49 CFR Part 572

Anthropomorphic Test Devices; Hybrid III 6-Year-Old Child Test Dummy, Hybrid III 6-Year-Old Weighted Child Test Dummy

ACTION: Final rule.

Figure 1: Illustration of femur assembly

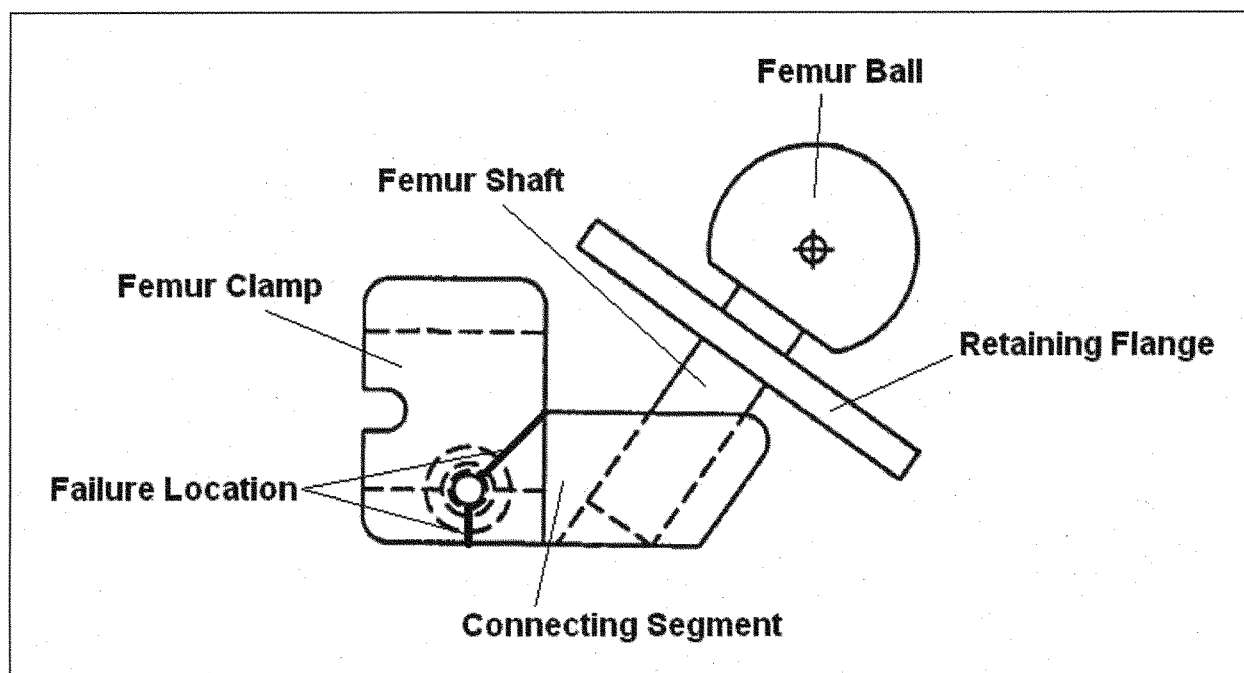
Failures of the HIII-6C femur appear to have initiated at a sharp corner between the femur clamp and connecting segment sections of the machined femur. The approximate location of the femur failure is depicted in Figure 1. The fracture was observed from this corner to the bolt hole within the femur clamp, at an angle of approximately 45°. The failure continued through the thin section of material directly beneath the bolt hole,

The modification made today to improve the femur’s durability increases the strength and durability of the femur assembly by fabricating the machined femur and shaft from 4340 steel, which has a higher yield strength than the original material, Aluminum Bronze C-624 AMC0-18, while keeping the ball and retaining flange as the original aluminum bronze material. A ¼-inch (6.35 mm) fillet is added between the

femur clamp and the connecting segment to eliminate stress risers that were present on the original femur, and a portion of the connecting segment

To implement this change in femur design and material, the following changes are made to the materials describing the HIII-6C in 49 CFR part 572. Drawings 127-3017-1&-2, “6 YR H3-FEMUR MACHINED” is replaced with drawings 127-3017-1S&-2S, which show the new machined femur.³ The femur assembly drawings (127-3016-1&-2) are also replaced due to the new femur design, with new part numbers 127-3016-1S&-2S. Higher assembly drawings including 127-3000, “LOWER TORSO ASSEMBLY” and the complete assembly drawings (127-0000) are amended to show the modified part. These revisions are noted on drawing SA572-127DRL-2. The PADI is also updated so that it shows the new machined femur in figures, and reports the proper lower torso assembly and total weight for the dummy. Finally, the part numbers for the machined femur and the femur assembly are changed in the Parts/Drawings list, along with the revision letters for higher assembly drawings, as appropriate.

Figure 7: Portions of the HIII-6C abdomen insert drawing

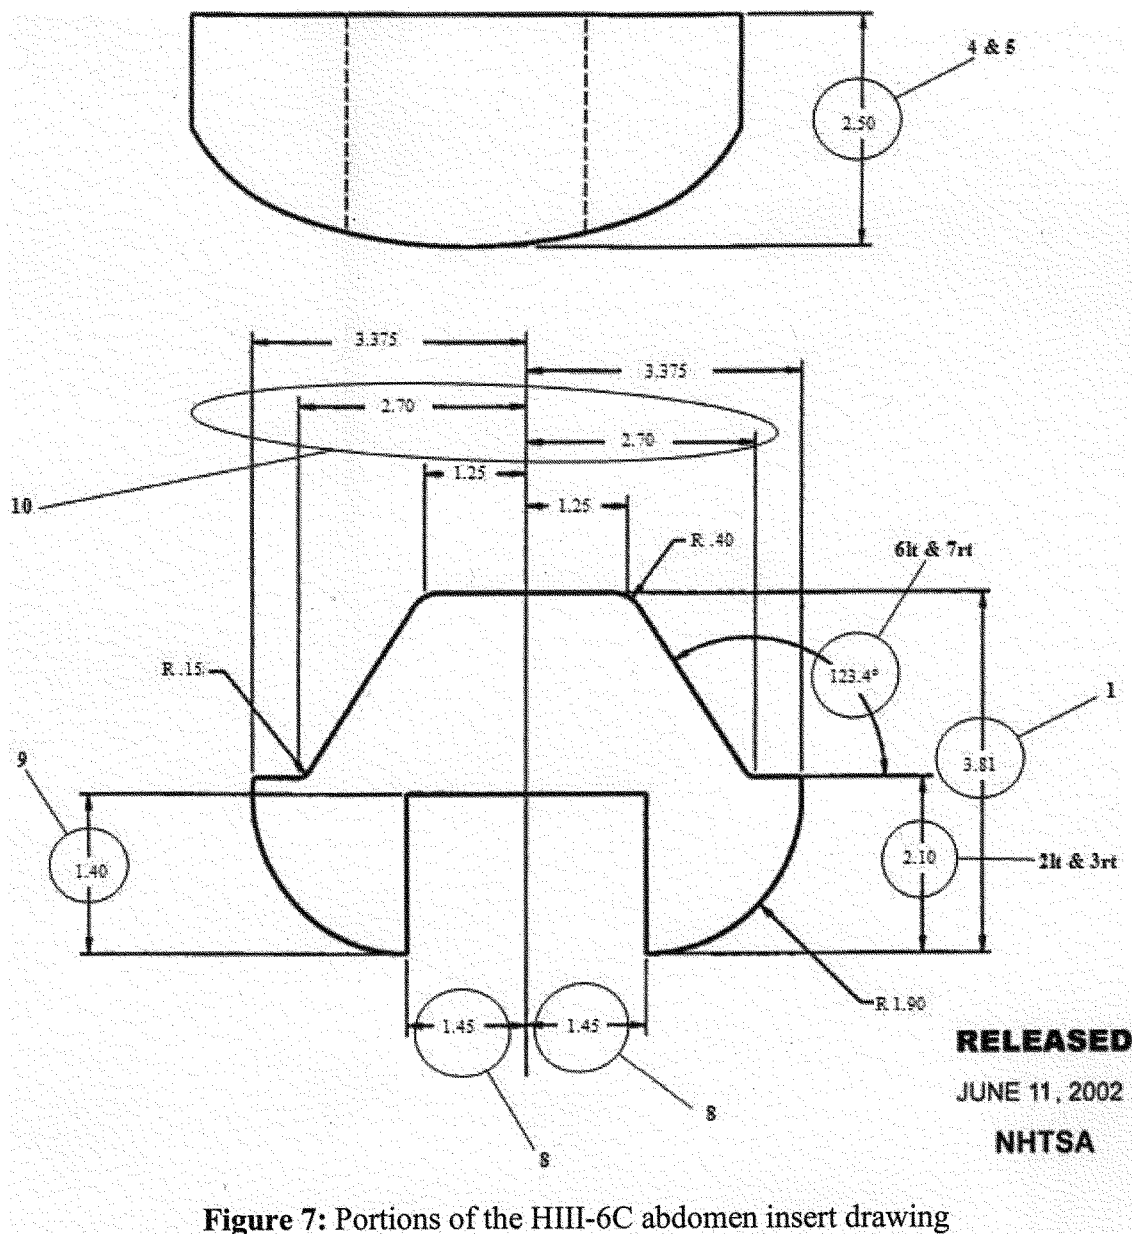
This final rule changes Drawing No. 127-8210 of the HIII-6C drawing package, which depicts the abdominal insert for the dummy. It makes a similar change to the HIII-6CW drawing package.⁸ This change responds to a petition from FTSS and Denton. Both manufacturers sought to revise the abdomen insert drawing to match the part mold dimensions.

In the NPRM, the agency granted the request but proposed to revise the drawing of the abdominal insert based on dimensions of actual abdominal inserts, rather than dimensions of the mold for the inserts. Nearly all changes were in agreement with the petitioners' mold-based dimensions.

Table 4 shows the changes this final rule makes to key abdomen dimensions. "Fig. Ref" numbers in the table refer to Figure 7, which shows the original dimensions.

Description	Fig. ref.	Adopted spec.
Overall height (in.)	1	3.81 +/- .20
Ledge height (in.)	2lt	1.53 +/- .20

Description	Fig. ref.	Adopted spec.
Depth excl. plug (in.)	3rt	1.53 +/- .20
Depth incl. plug (in.)	4	2.80 +/- .20
Taper angle of cone (degrees)	5	2.80 +/- .20
	6lt	121/129
	7rt	121/129
Notch Half Width (in.)	8	1.50 +/- .20
Notch Depth (in.)	9	1.40 +/- .20
Width Bottom of Cone (in.)	10	5.40 +/- .40
